SHOREHAM NUCLEAR POWER STATION

Safety Evaluation Report Issue No. 8  
Dynamic Qualification  
Shoreham Nuclear Power Station - Unit 1  
Docket No. 50-322

## GENERIC ITEMS

DISPLACEMENT OF HOUSING

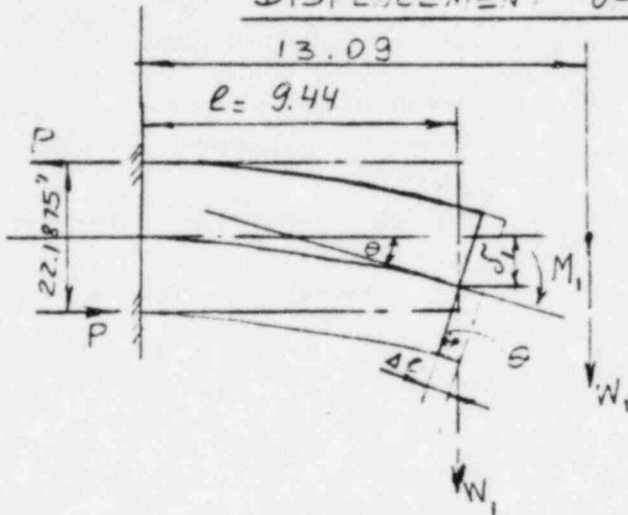
A static deflection analysis was provided for the fan only. A clearance of .051" was noted between the fan and housing. Provide upgraded calculations to also include the deflection of the housing.

THE RESULTS OF THIS CALCULATION SHOW THE DEFLECTION OF THE HOUSING, IS  $6.0 \times 10^{-3}$  IN.

$W_1 = W \times g \times 1.25 =$   
 $425 \times 1.2 \times 1.05 = 536$   
 WHERE  $W$  - TOTAL WEIGHT  
 OF THE FAN (CONSERVATIVE)  
 $g$  - HORIZONTAL SEISMIC  
 ACCELERATION FOR DBE  
 (REF. 1, PART 1, PG. 6, 8)

Fig. E-1 RACKOE Model used for ANSYS Comparison

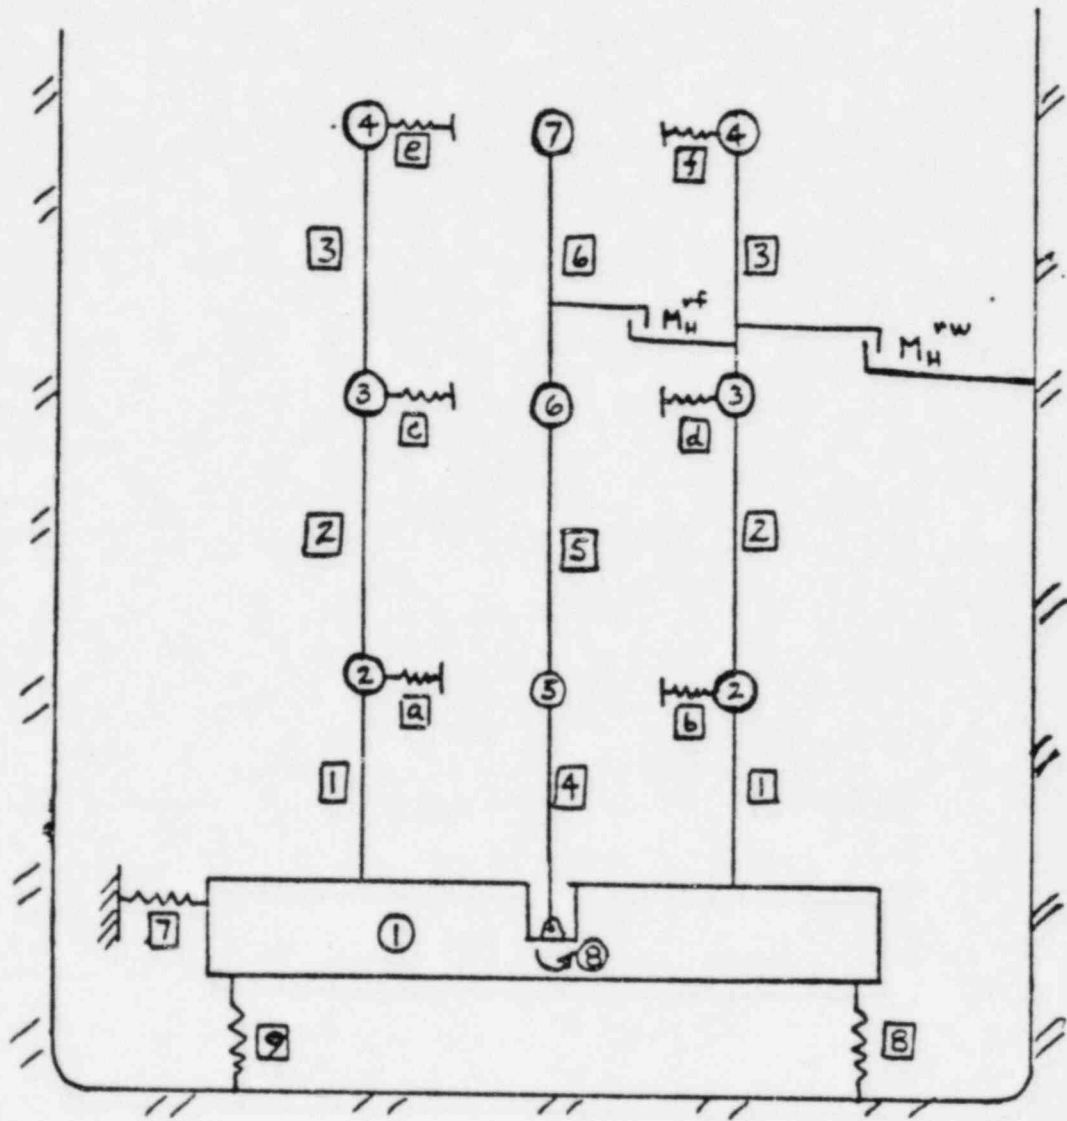
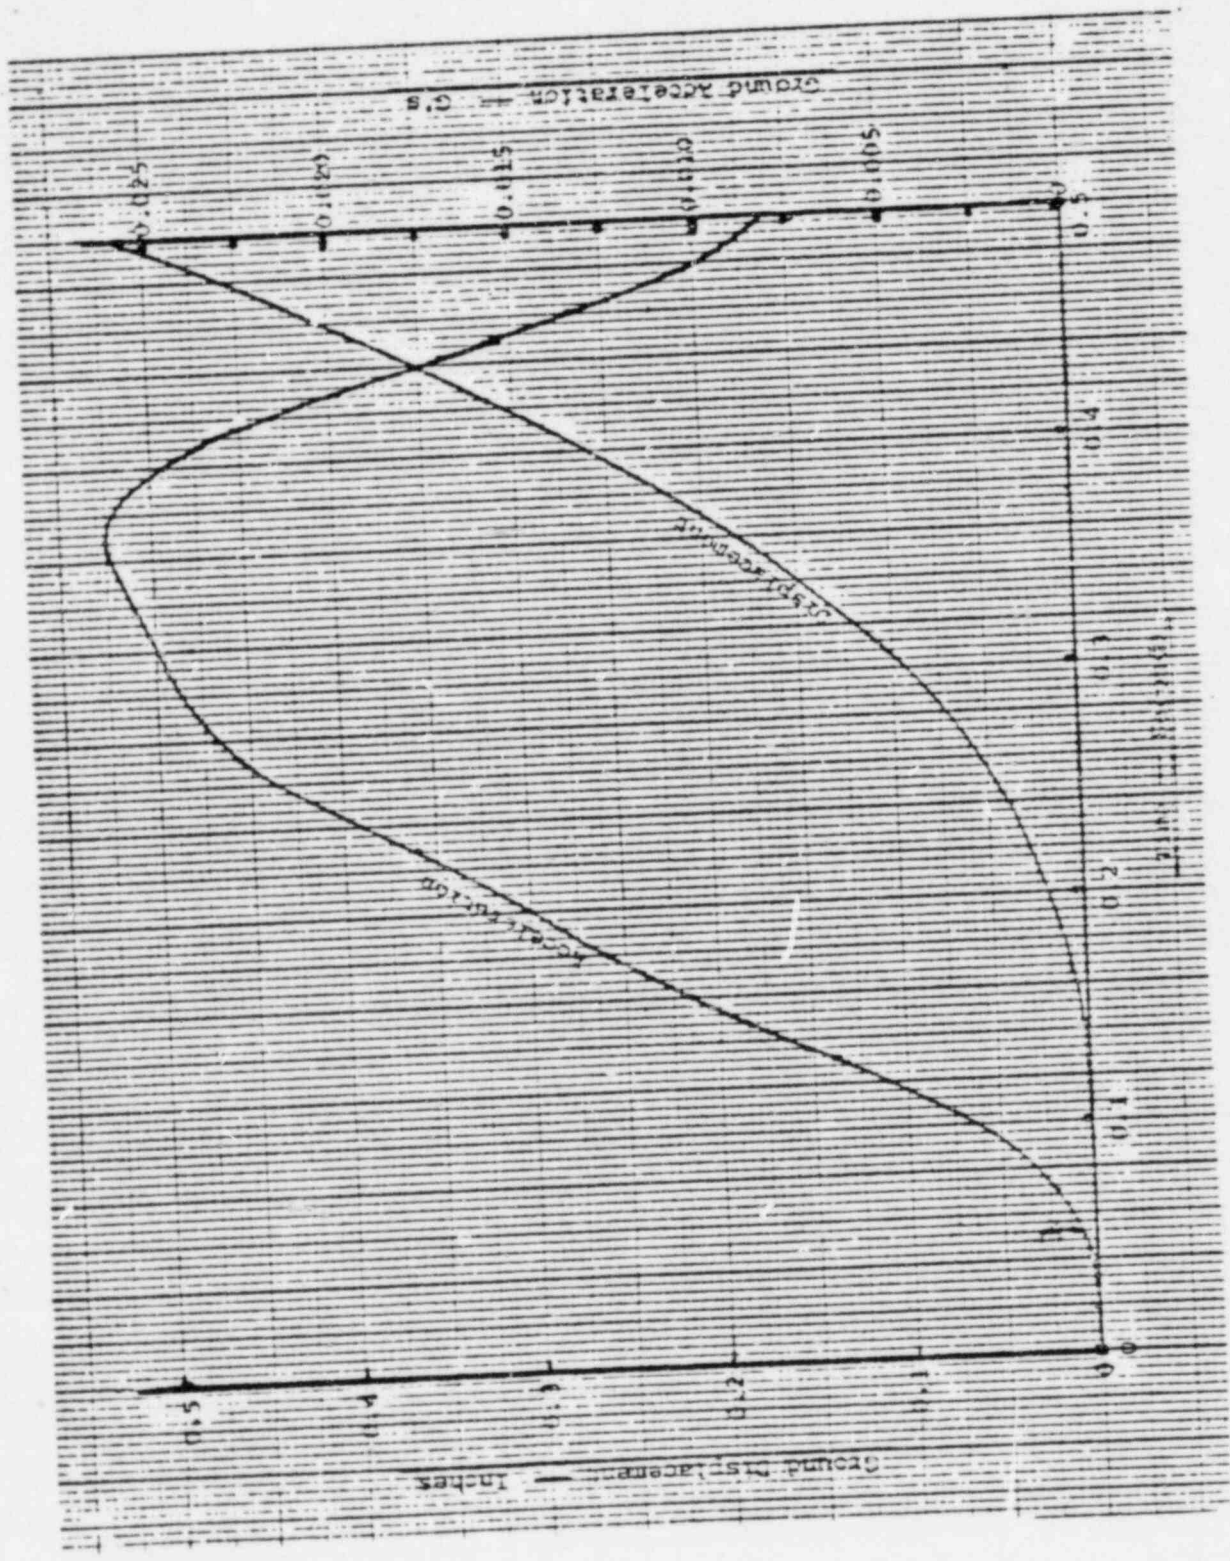
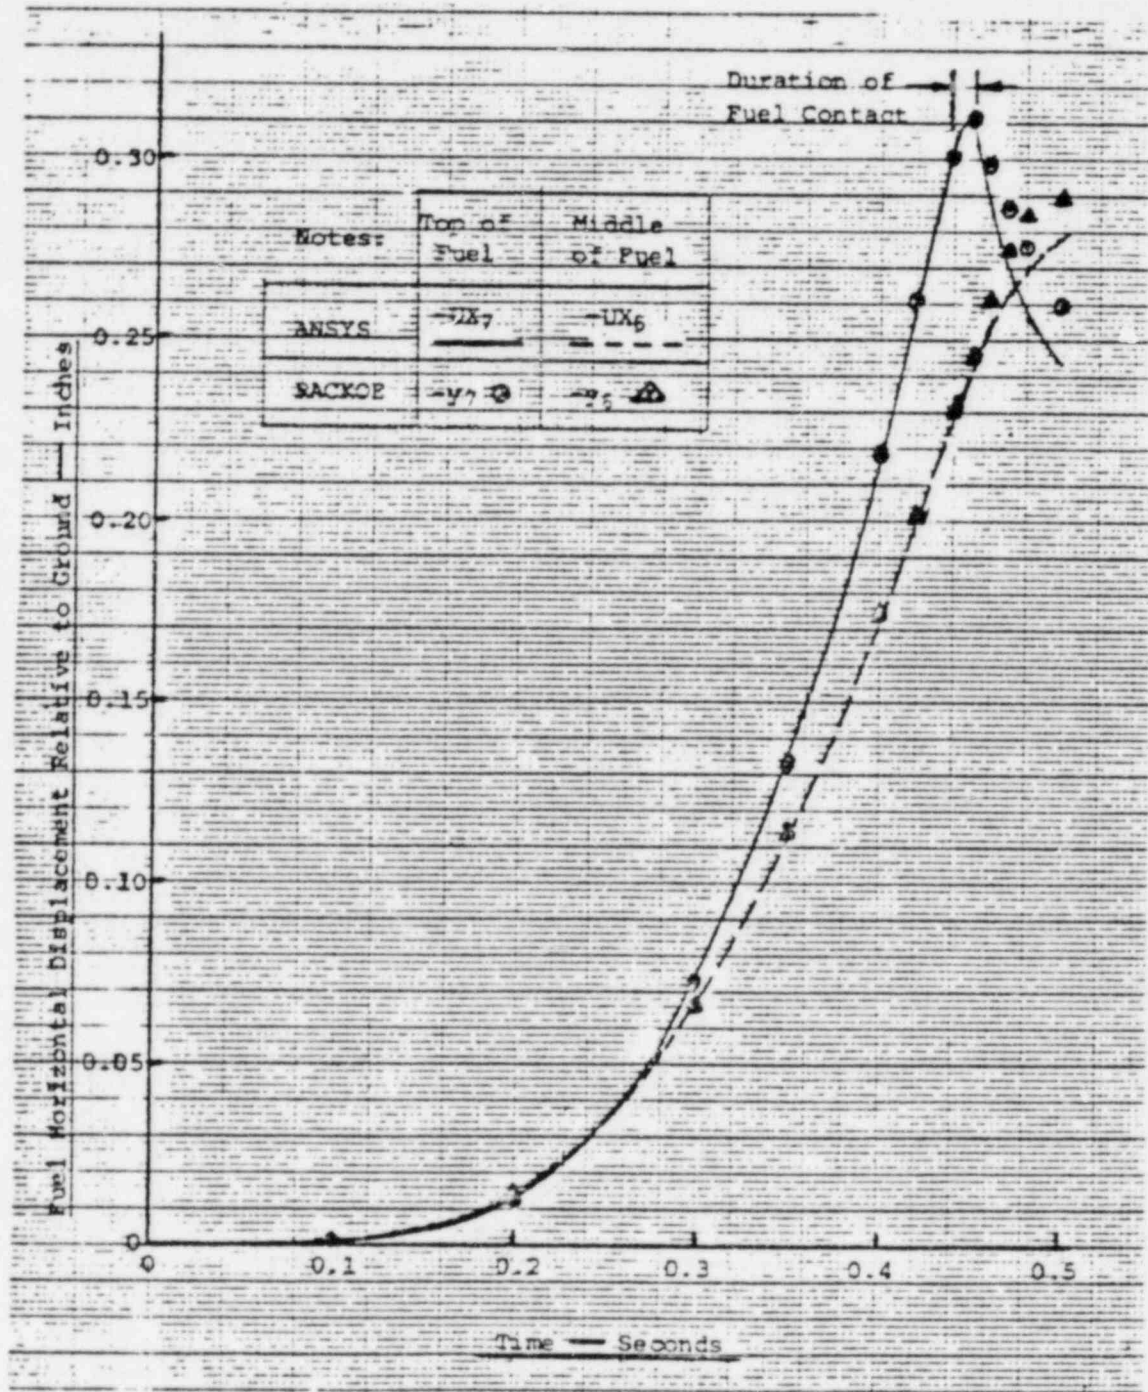
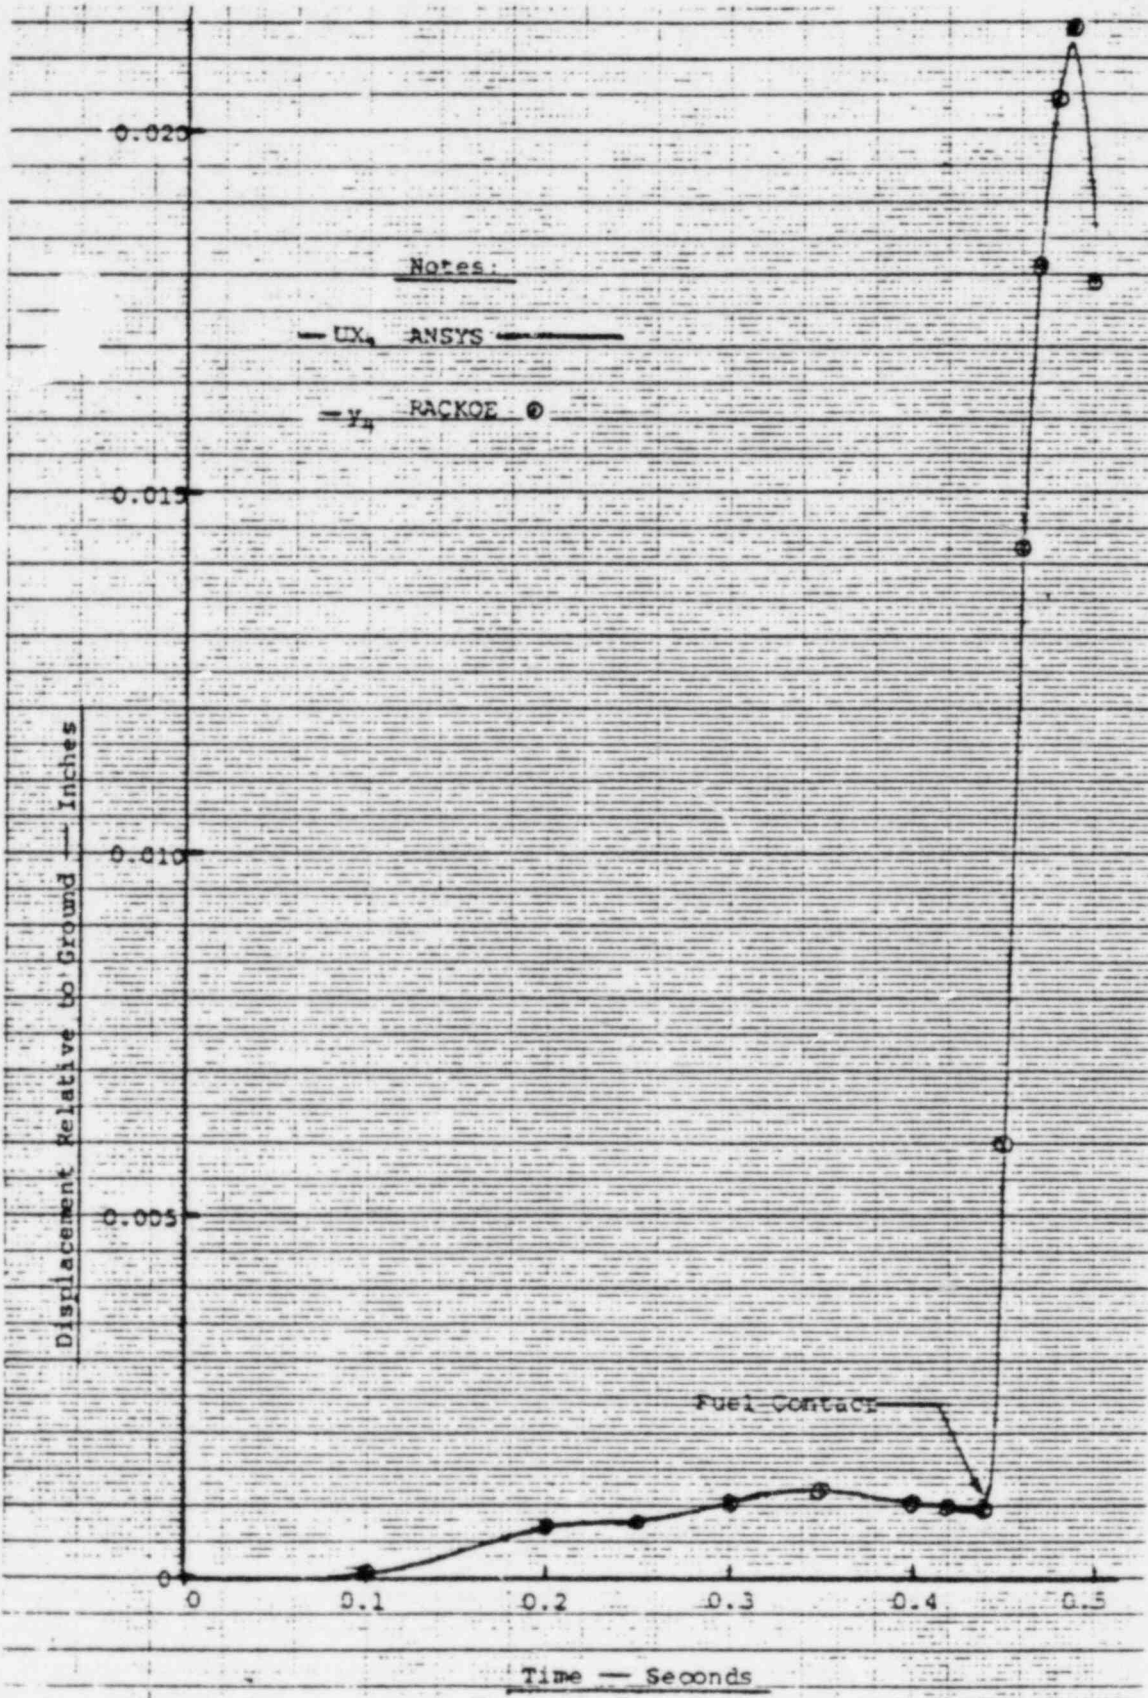
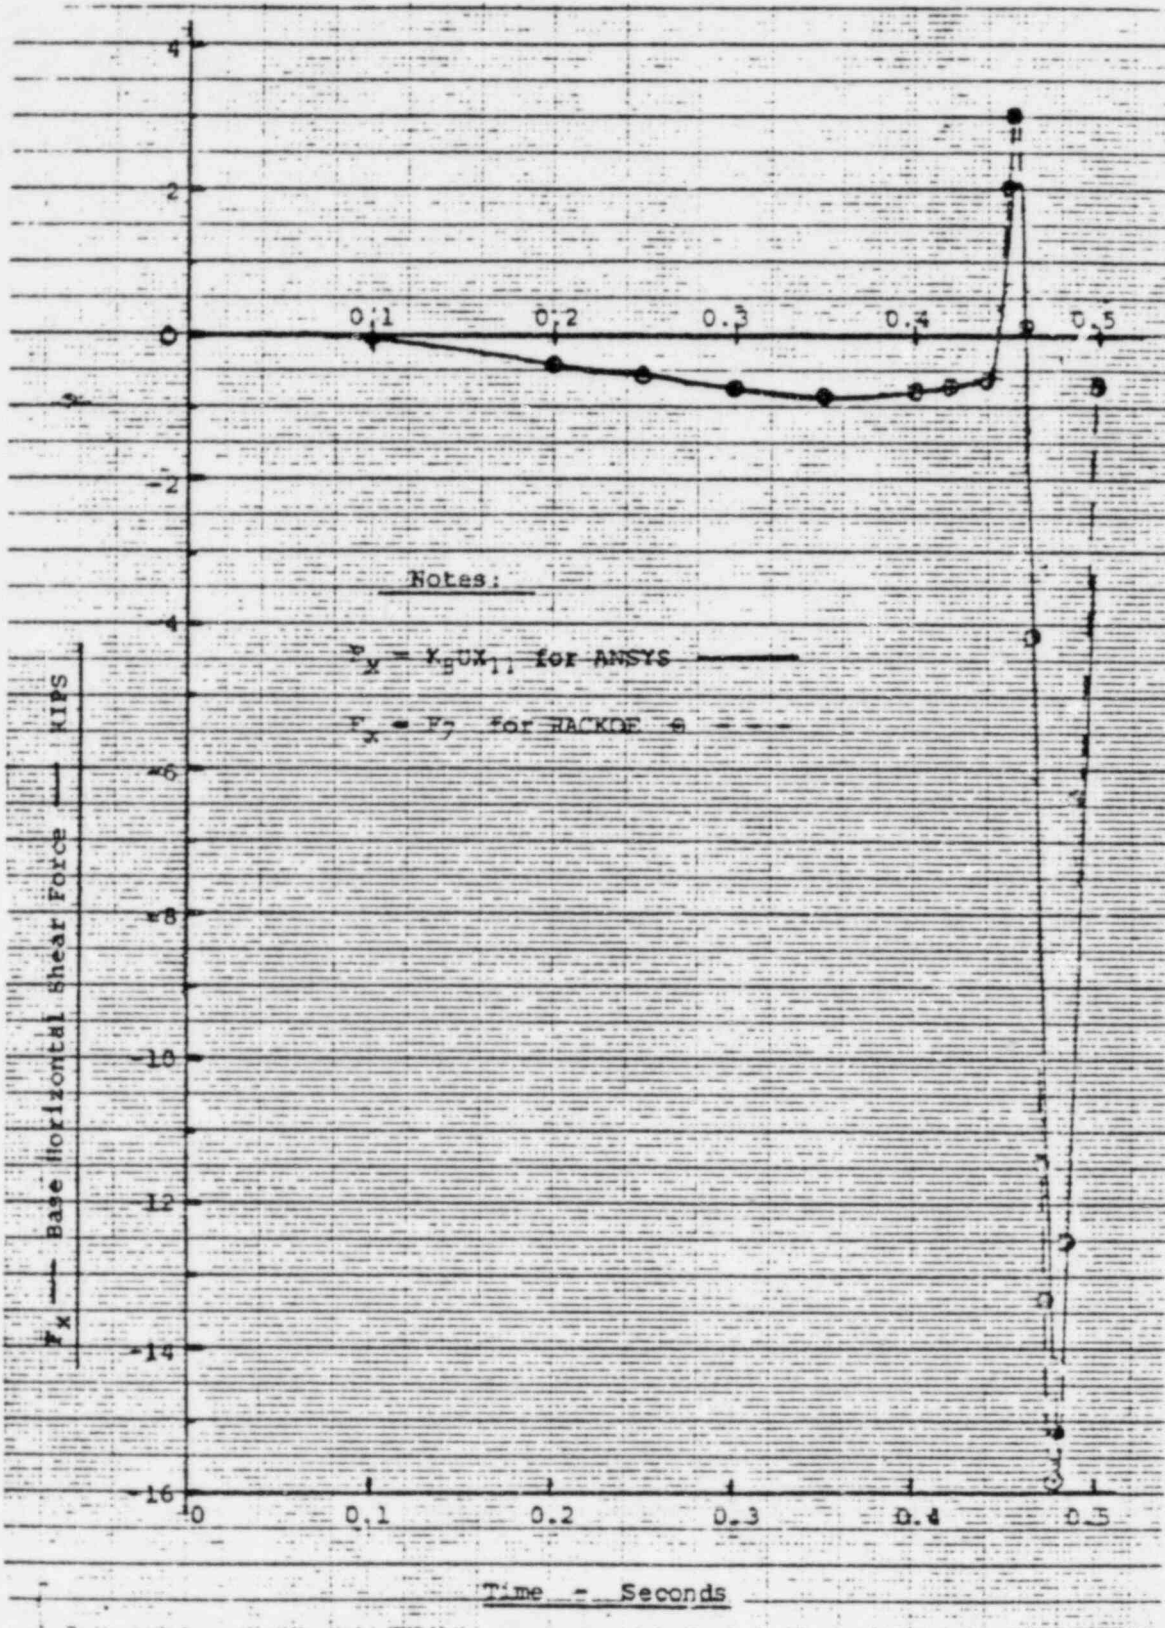
2. Permanent Control Rod Storage Rack - 1F16\*RAK-23  
Package No. SH1-427-1
  - a. The qualification loads report was not available in the SQRT file. Need clarification
  - b. Provide evidence of verification for the non-linear analysis code used.
  - c. Loads were not properly defined (i.e., a time history was used, but there was no description of what it represented). Provide clarification.

Figure E-1 shows the model used for checking RACKOE against the more general structural analysis program ANSYS (Ref. E3). To verify the essential feature of RACKOE everything except structural damping in eq. (E-5), ANSYS was run only until and slightly after a fuel contact occurred. As input, both programs used the input ground acceleration shown in Fig. E-2. For completeness, the absolute ground displacement is shown.

Considering the detailed agreement between ANSYS and RACKOE in this comparison run, the basic one stick fuel impact model is considered verified. Various options of RACKOE are discussed and justified in attachments to this appendix.
